RECALL: This modification has top priority and must be performed immediately to ensure customer safety

Subject: Factory Direct Modification Campaign – New Software Update to the Suspension Control Unit (SCU) and inspection of Shock Absorber for any possible oil leak at the Rebound Damping plug

Affected 2015 & 2016 Model: 1290 Super Adventure

Figure 1.

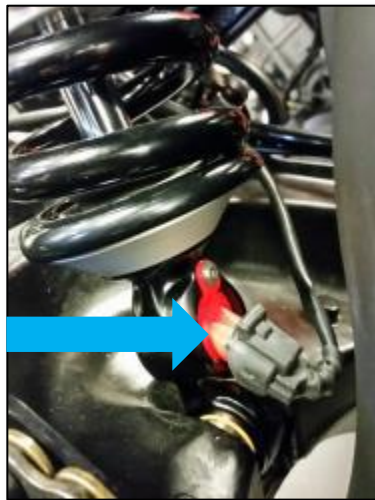
- » Inspecting the shock for an oil leak.
 1. Remove the Rebound Damping plug connector from the shock absorber.
 2. Inspect for any oil leak visible on the outside and also inside the connection terminal of the rebound damping plug connection (Figure 1.)

3. If leaking is present, replace the shock strut (without preload adjuster and spring) PN# 46812001S1. Follow the latest available repair manual for replacement procedure. If no oil leaking is present, continue to ECU flashing steps below.
